FINAL DRAINAGE PLAN

THE RIDGE AT LORSON RANCH

FILING NO. 1: SF 22-XX ← SF224

JANUARY, 2022

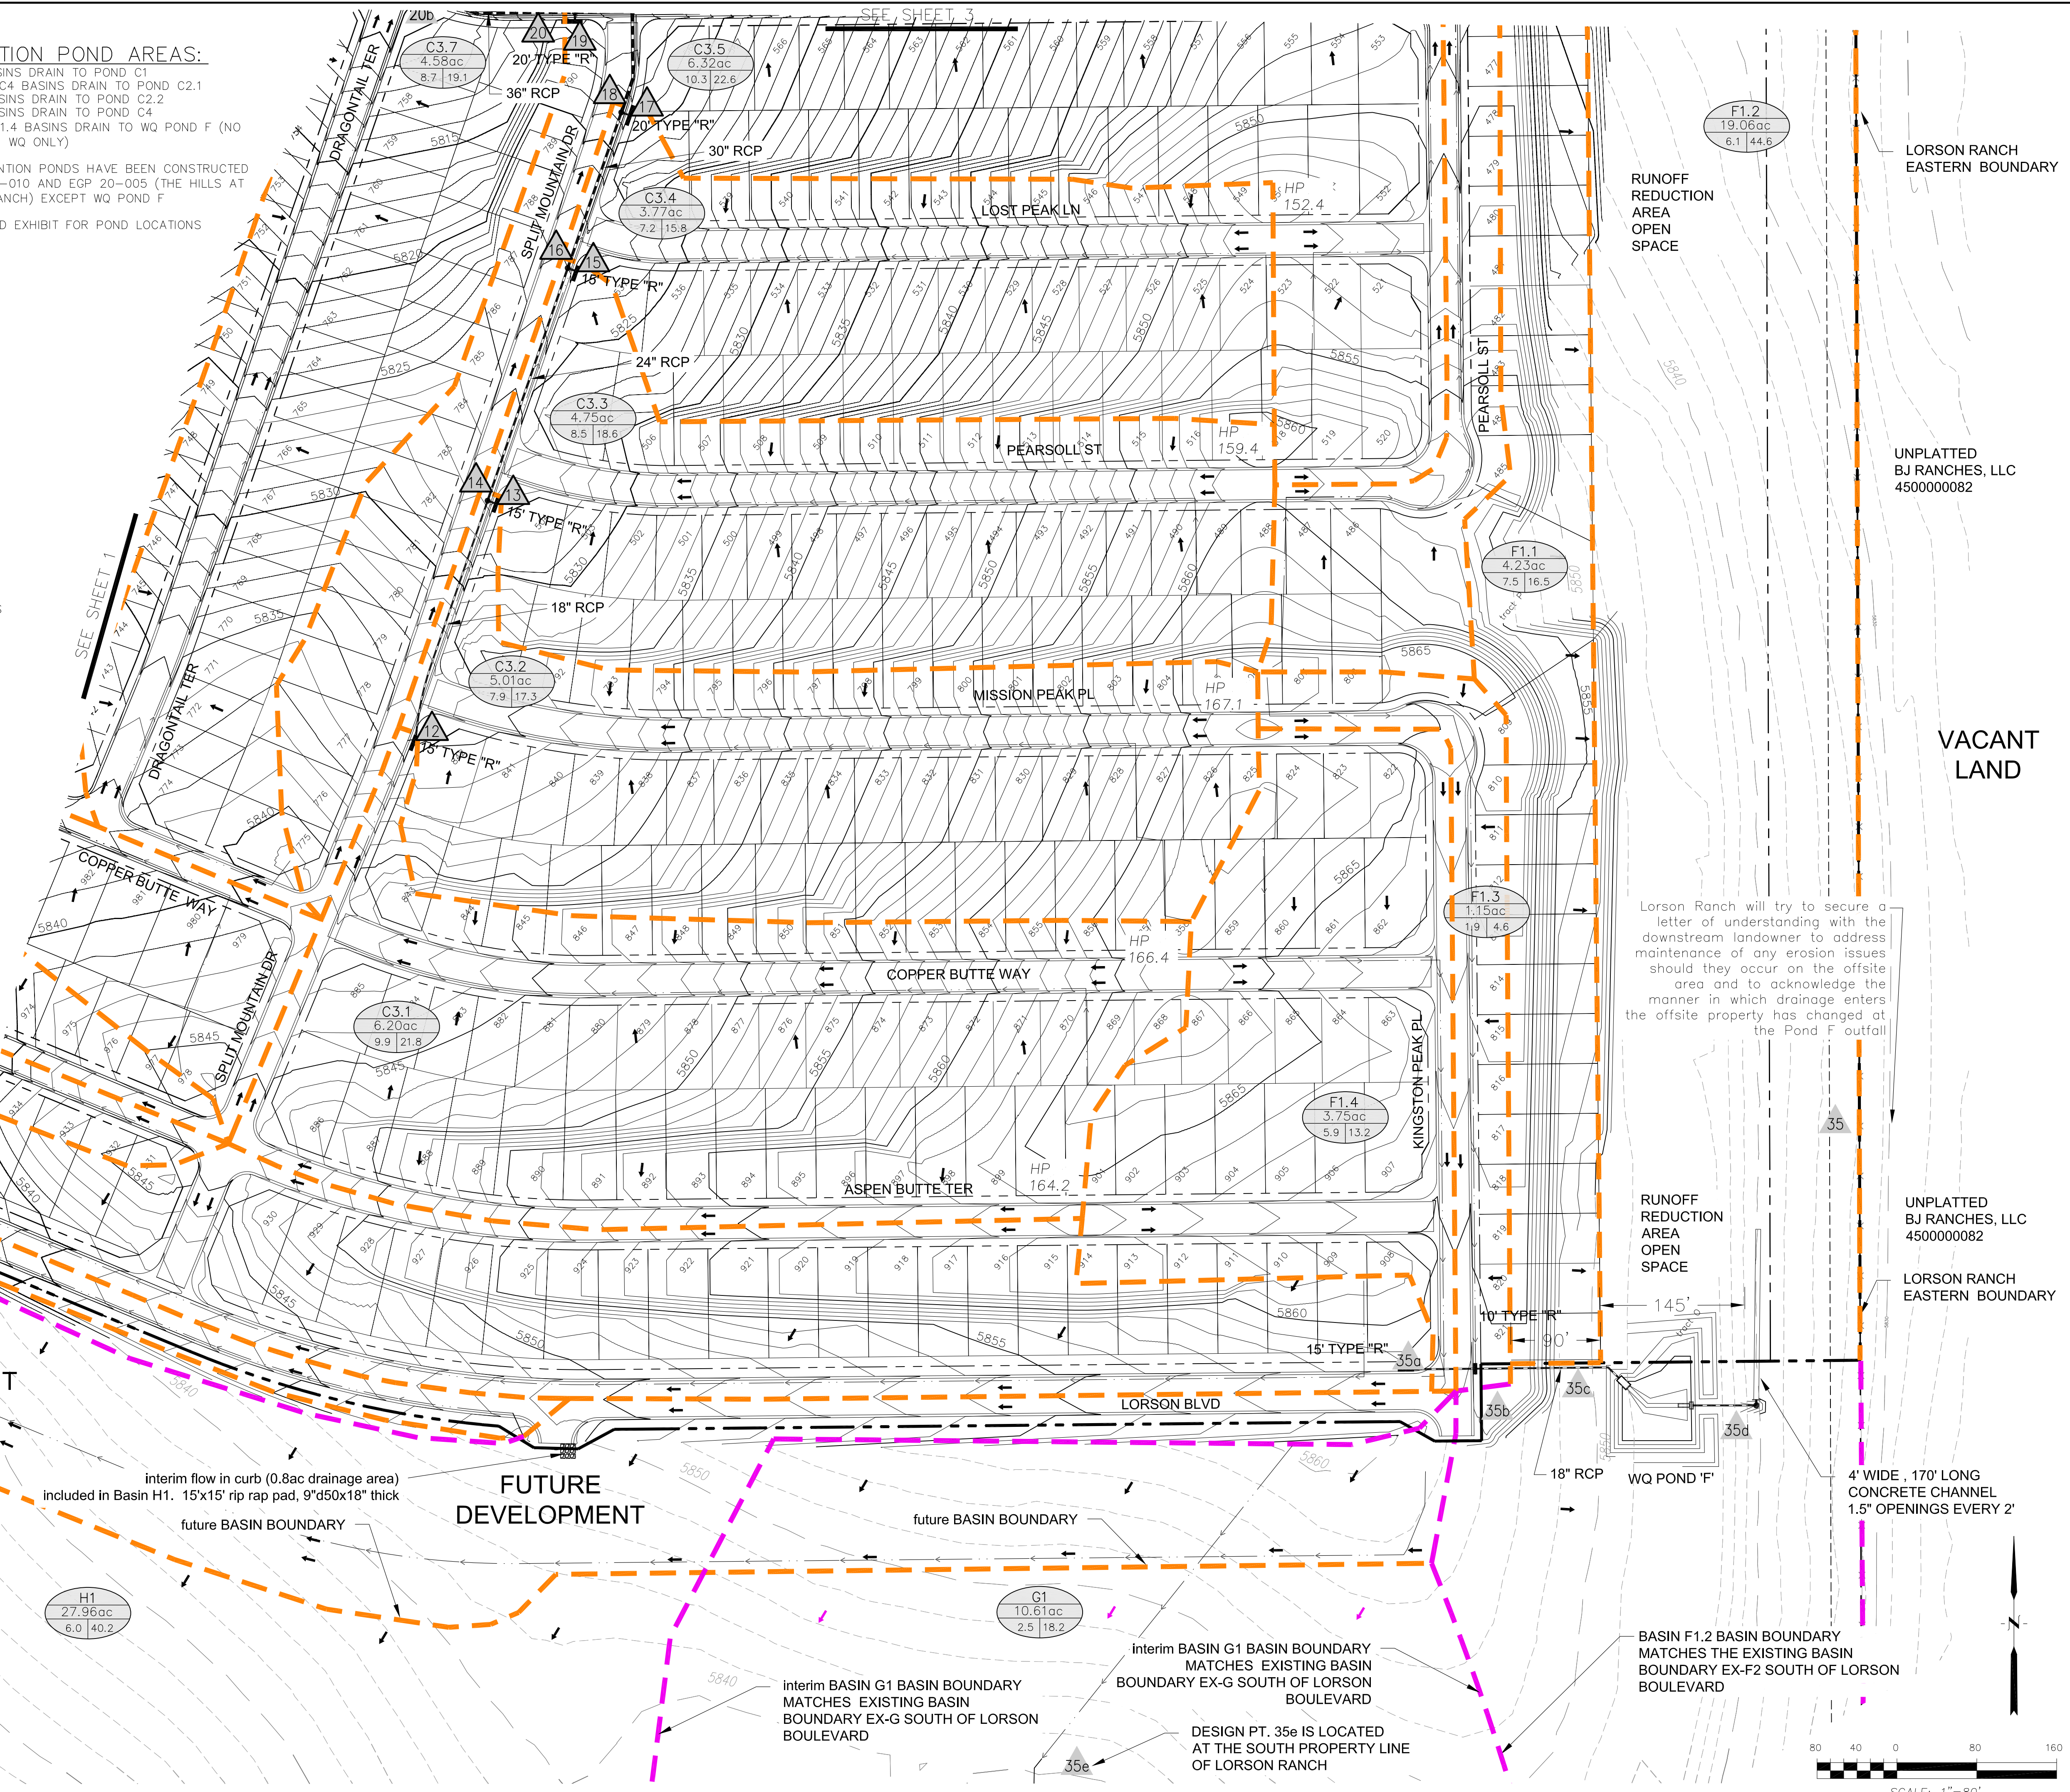
Lorson Ranch will try to secure a letter of understanding with the downstream landowner to address maintenance of any erosion issues should they occur on the offsite area and to acknowledge the manner in which drainage enters the offsite property has changed at the Pond F outfall

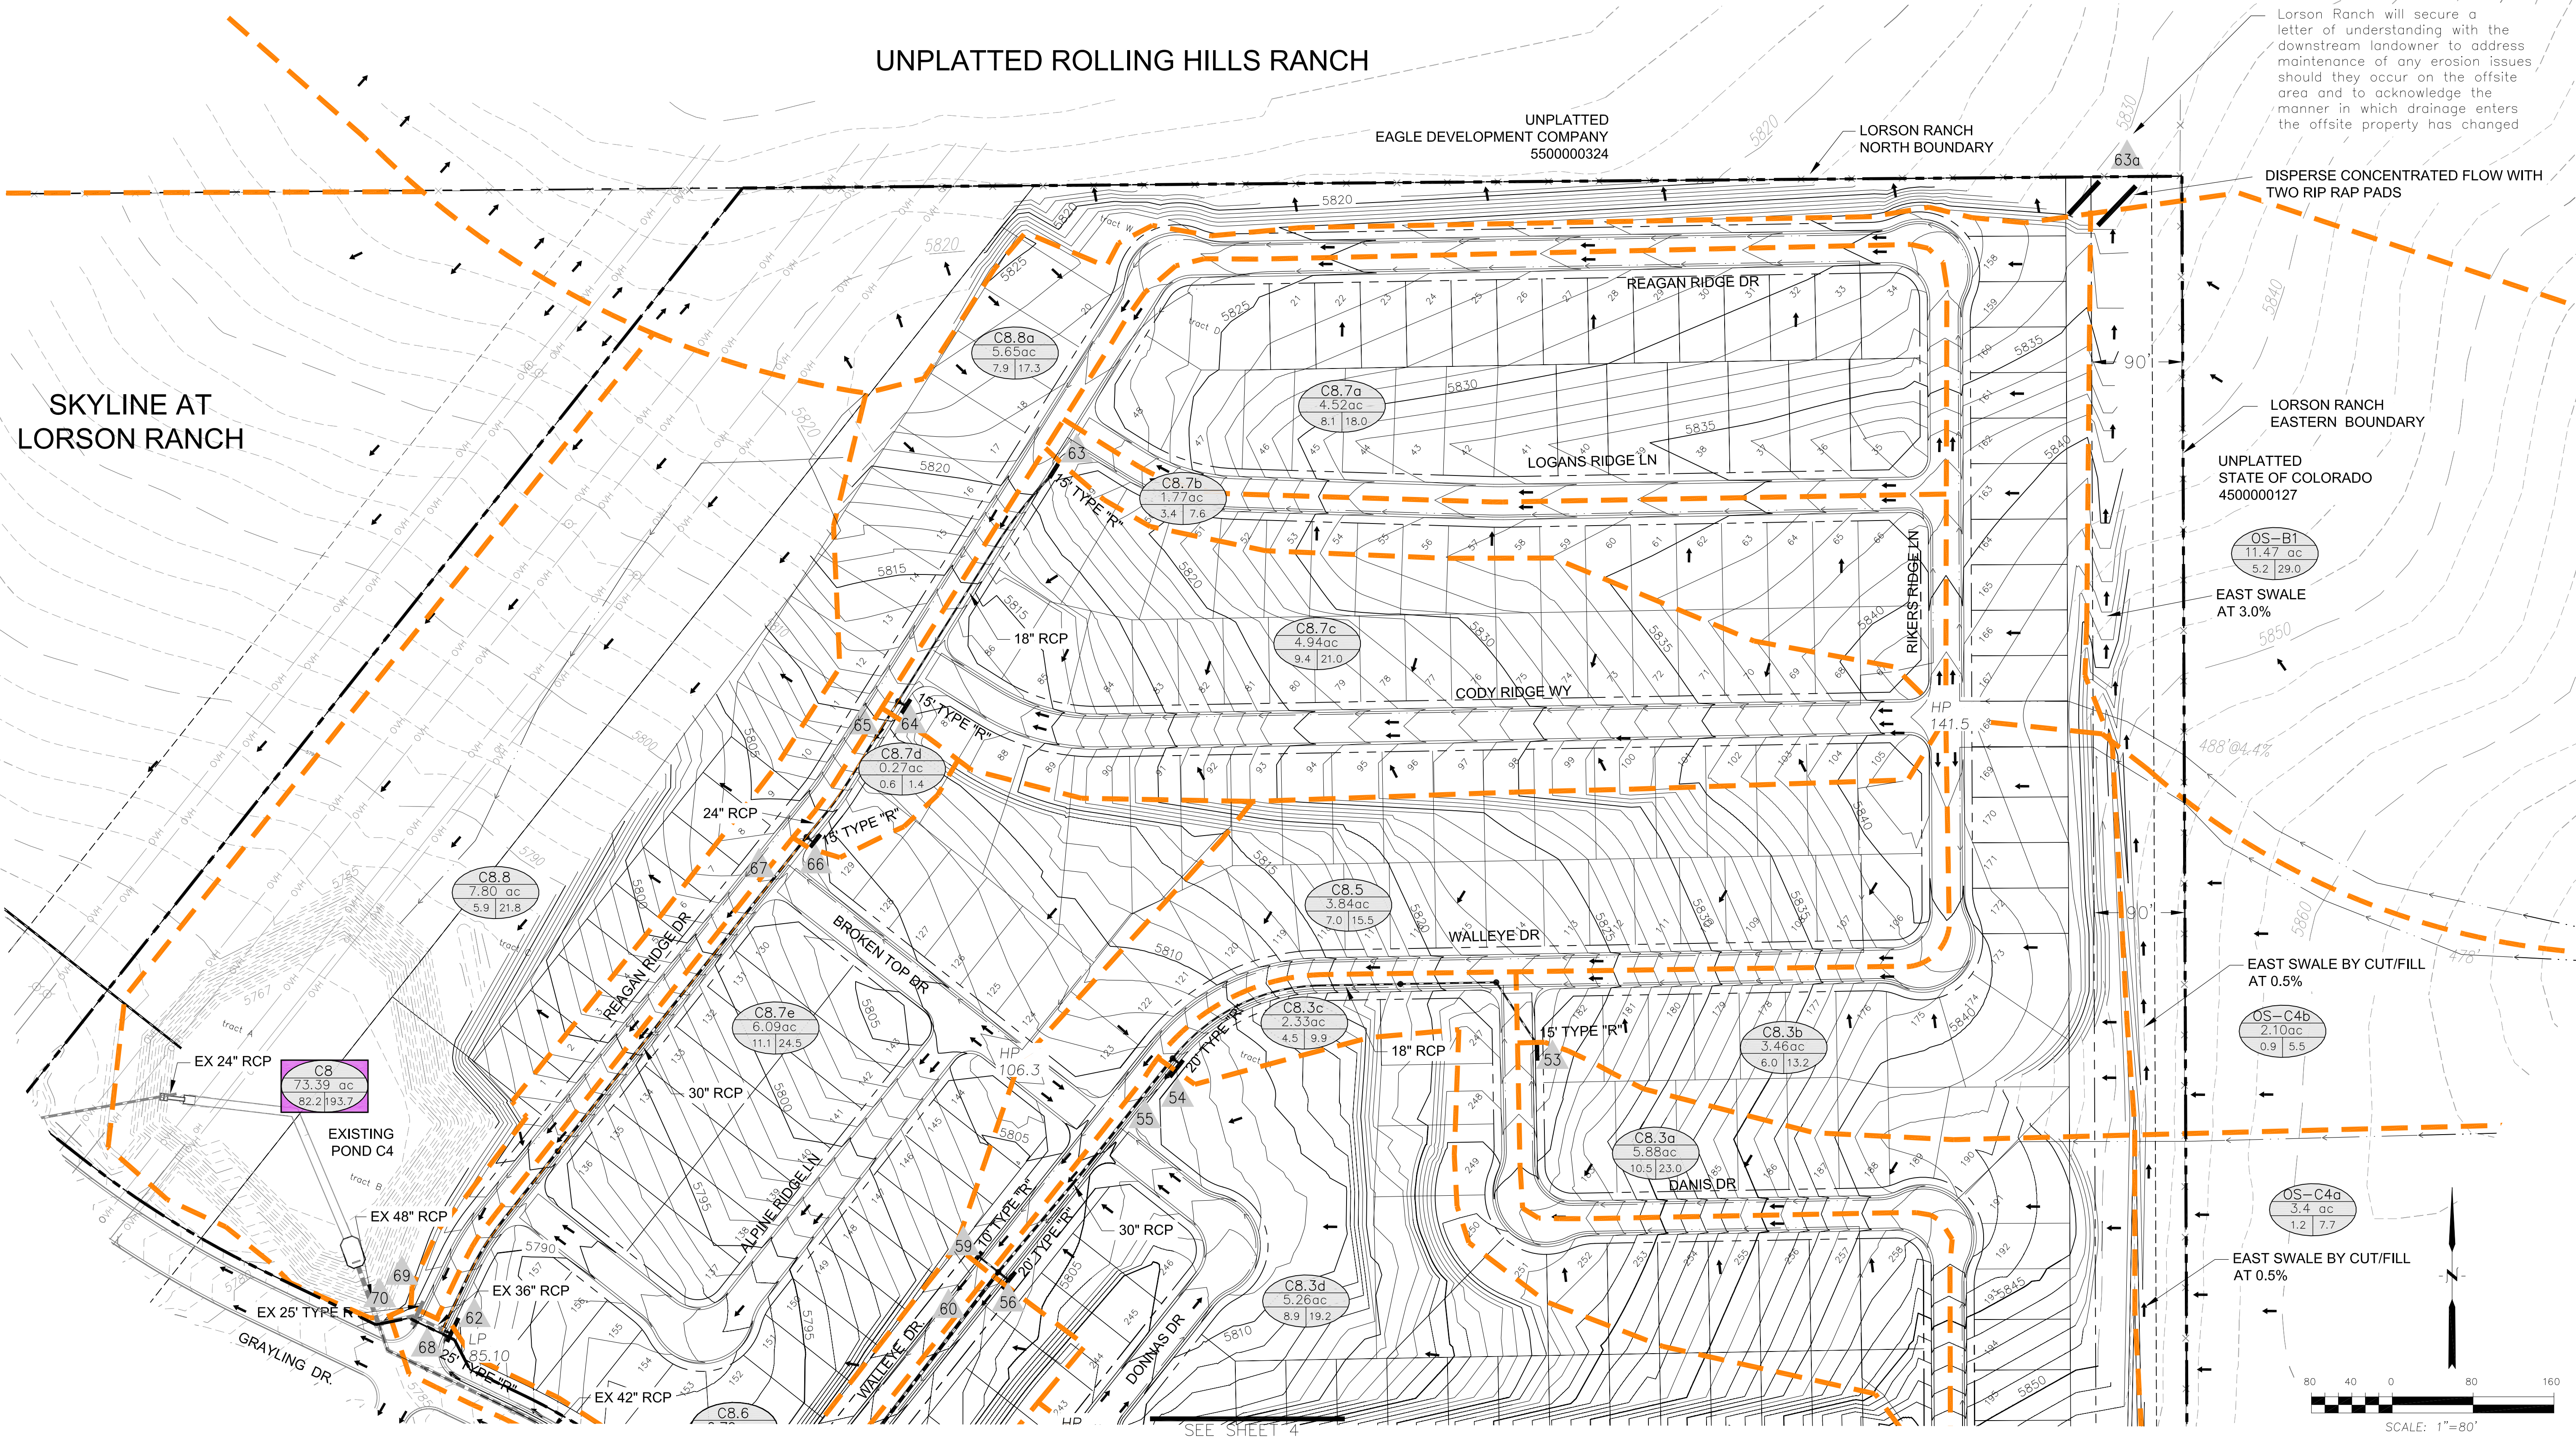
Lorson Ranch will secure a letter of understanding with the downstream landowner to address maintenance of any erosion issues should they occur on the offsite area and to acknowledge the manner in which drainage enters the offsite property has changed
